# Access Compliance Report

## Public Rights-of-Way

Intersection ID: 29162	Main Street: FIRESTREAK_DR	Cross Street: ADVOCATOR_LN	Location:	SW
ADA ID: 599A64772ED3	Ramp Type: Perp	Initial Pass/Fail: Fail	Overall Compliance: No	Severity Score: 60
Codes/Mitigation Info/Possible Solution		Field Measurements/Component Compliance

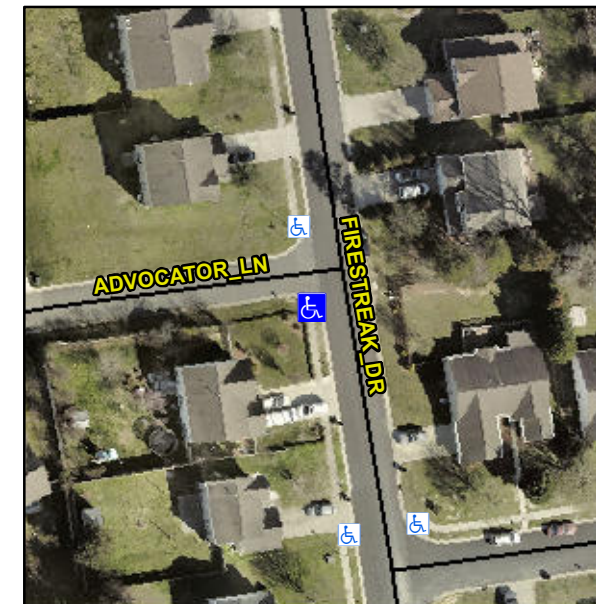
**Not Found, R304.5.1, R304.5.3**

Compliance	Description	Data	Compliance	Description	Data
N/A	Ramp Length (in)	49.0	Yes	Ramp Slope (%)	5.0
No	Ramp Width (in)	30.0	No	Ramp XSlope (%)	7.5
N/A	Flare Type LT	N/A	N/A	Flare Type RT	N/A
N/A	Flare Slope LT (%)	N/A	N/A	Flare Slope RT (%)	N/A
N/A	Flare Traversable LT?	N/A	N/A	Flare Traversable RT?	N/A
N/A	Landing Length (in)	N/A	N/A	DWS Provided?	N/A
N/A	Landing Width (in)	N/A	N/A	DWS Contrast?	N/A
N/A	Landing Slope (%)	N/A	N/A	DWS Length (in)	N/A
N/A	Landing X Slope (%)	N/A	N/A	DWS Full Width?	N/A
N/A	Landing Curb? (Y/N)	N/A	N/A	DWS Offset (in)	N/A
N/A	Shared Landing?	N/A			
N/A	Gutter Ponding?	N/A	N/A	Gutter Slope (%)	N/A
N/A	Gutter Lip Ht (in)	N/A	N/A	Gutter X Slope (%)	N/A
N/A	Painted X Walk1?	No	N/A	Painted X Walk2?	N/A
	X Walk 1 Direction	To N		X Walk 2 Direction	N/A
N/A	X Walk 1 Width (in)	N/A	N/A	X Walk 2 Width (in)	N/A
	X Walk 1 Slope (%)	2.2		X Walk 2 Slope (%)	N/A
	X Walk 1 X Slope (%)	5.5		X Walk 2 X Slope (%)	N/A

**Remove & Replace Entire Ramp.**
